# **10GBASE-T Fast Retraining and EEE PCS and PHY Control State Diagram Changes**

IEEE P802.3az Task Force  
Geneva, May 2010

# Overview

# Figure 55-24 PHY Control State Diagram (2 of 2) (Changes in Blue)

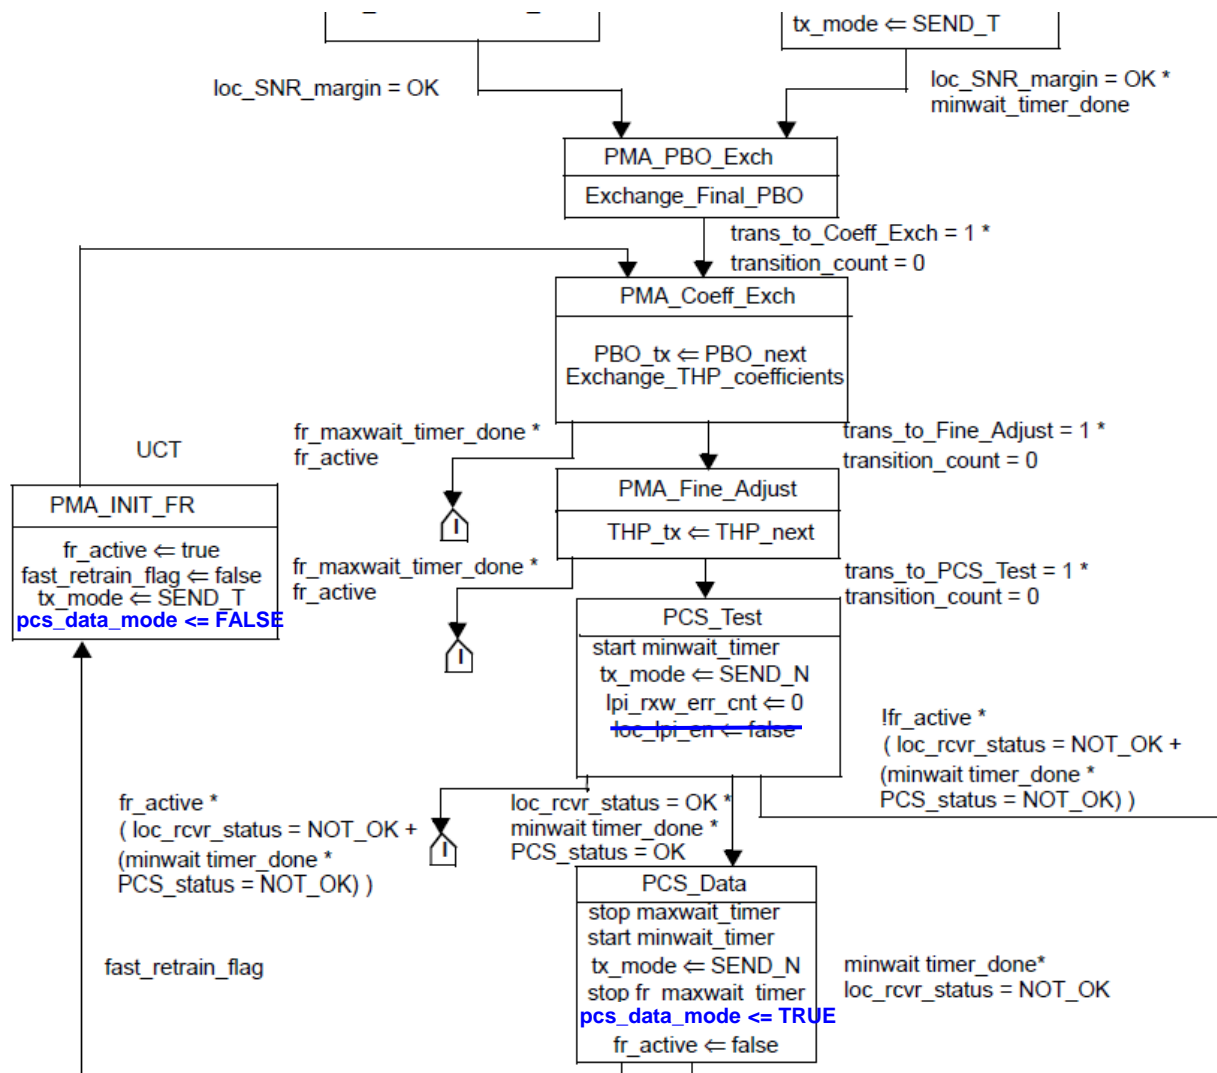
- Redefine loc\_lpi\_en as pcs\_data\_mode so that it can be used to hold state diagrams when the PHY Control is not in PCS\_Data.
  - Set pcs\_data\_mode to FALSE in PHY Control states SILENT and PMA\_INIT\_FR and set TRUE in PCS\_Data.
  - Update variable, primitive, functional block diagrams, and PHY Control State Diagram reflecting this change.
- PCS 64B/65B PCS Transmit
  - Hold in state TX\_INIT when not in PCS\_Data.
  - Eliminate transitions dependent on loc\_lpi\_en since these are no longer needed.
- PCS 64B/65B PCS Receive
  - Hold in state RX\_INIT when not in PCS\_Data.
  - Results in local faults being sent to RS up through the end of PCS\_Test.
- EEE Transmit state diagram
  - Hold in state TX\_NORMAL when not in PCS\_Data.

# Figure 55-3 Functional Block Diagram (Changes in Blue)

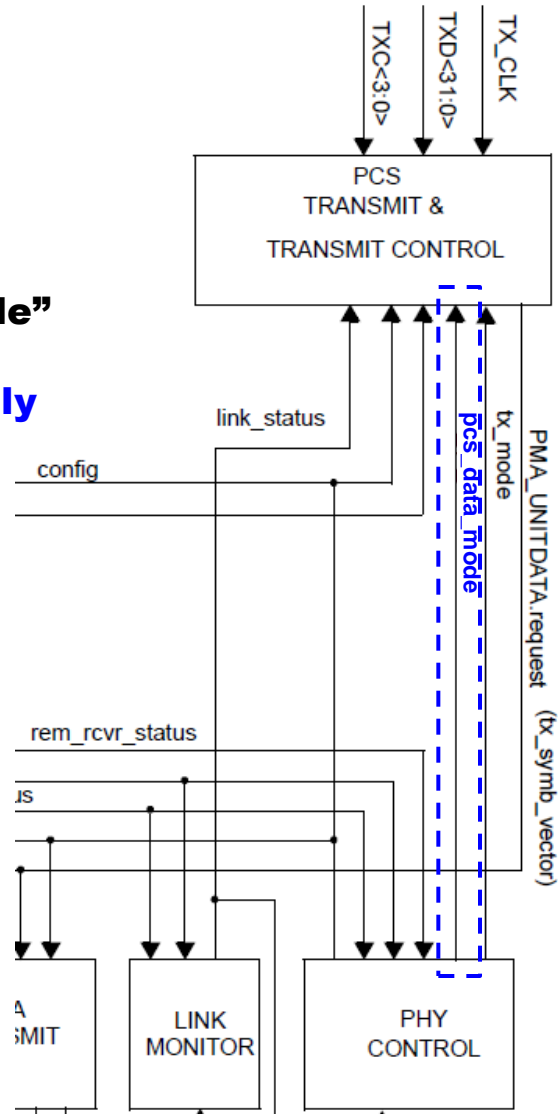
Page 183, line 23 Replace  
“loc\_lpi\_en” with “pcs\_data\_mode”

Add a note to indicate this is only  
required for EEE and Fast  
Retraining.

## 55.2.2.11 PMA\_PCSDATAMODE.indication

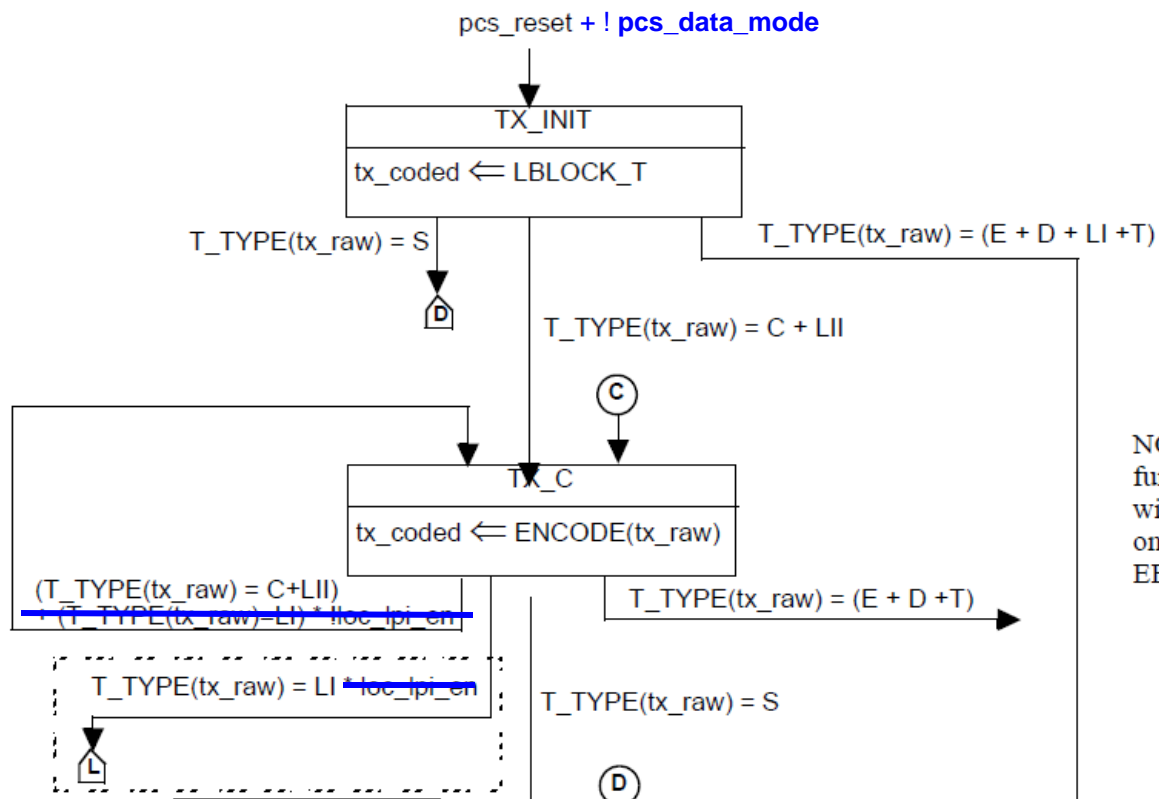
- Page 185, line 37 (55.2.2) Replace “PMA\_LOCLPIEN.indication (loc\_lpi\_en)” with “PMA\_PCSDATAMODE.indication (pcs\_data\_mode)”
- Page 186, line 16 (Fig 55-4) Replace “PMA\_LOCLPIEN.indication” with “PMA\_PCSDATAMODE.indication”
- Page 188, line 10, Change 55.2.2.11 to:

This primitive indicates whether or not the PCS state diagrams are able to transition from their initialization states. The pcs\_data\_mode variable is generated by the PMA PHY Control function and indicates whether or not the PCS state diagrams are able to transition from their initialization states. It is passed to the PCS Transmit Control function via the PMA\_PCSDATAMODE.indication primitive.
